Subject: Fuel Leak Case No. RO0000066 and GeoTracker Global ID T0600100208, BP #11126,
1700 Powell Street, Emeryville, CA 94608

Alameda County Environmental Health (ACEH) staff has reviewed the case file for the above-referenced site including the recently submitted document entitled, "Response to ACEH Correspondence Dated February 1, 2007," and the "Remedial Action Plan," both dated March 30, 2007, which were prepared by SECOR International Incorporated, now Stantec Consulting Corporation (Stantec) for the subject site. In our February 1, 2007 correspondence, ACEH requested groundwater contaminant plume delineation to the west of the site and a Remedial Action Plan to address source area contamination that may be adding contaminant mass to the dissolved-phase contaminant plume in groundwater currently present at the site.

Figure 1: Groundwater Elevation Contours

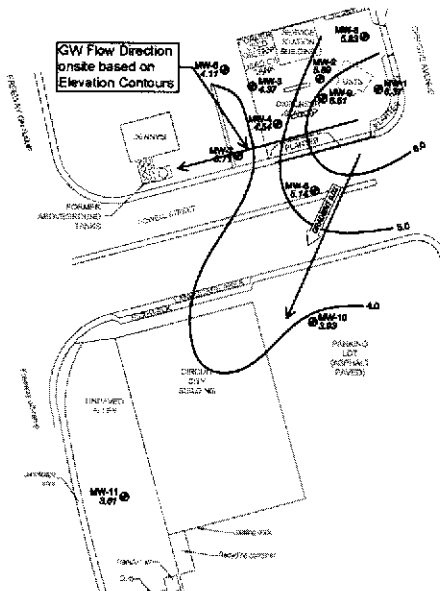
Based on the groundwater elevation contours in Stantec's January 23, 2009, "Quarterly Monitoring Progress Report Fourth Quarter 2008," it would appear that there may be at least two different gradients directions present at the site (see Figure 1). While Stantec identifies that the groundwater gradient is to the southwest, to which ACEH concurs, Stantec does not consider the possibility that there may be a westerly component of groundwater flow direction at the site, as illustrated on Figure 1. Figure 2 illustrates the TBA concentrations detected in groundwater samples collected at the site. Based on the isoconcentration contours, the down-gradient extent of the TBA plume appears undefined in the direction of the plume axis. Concentrations of TBA in monitoring well MW-7 appear to have been increasing in the recent past with TBA being detected at 3,500 µg/L during the fourth quarter 2008 monitoring event. Since concentrations of TBA appear to be increasing and the extent of the contaminant plume in the western direction appears undefined, based on groundwater elevation contours and TBA isoconcentration contours, a work plan to define the extent of the groundwater contaminant plume is required. Please propose a scope of work to address the above-mentioned concerns and submit a work plan due by the date specified below.
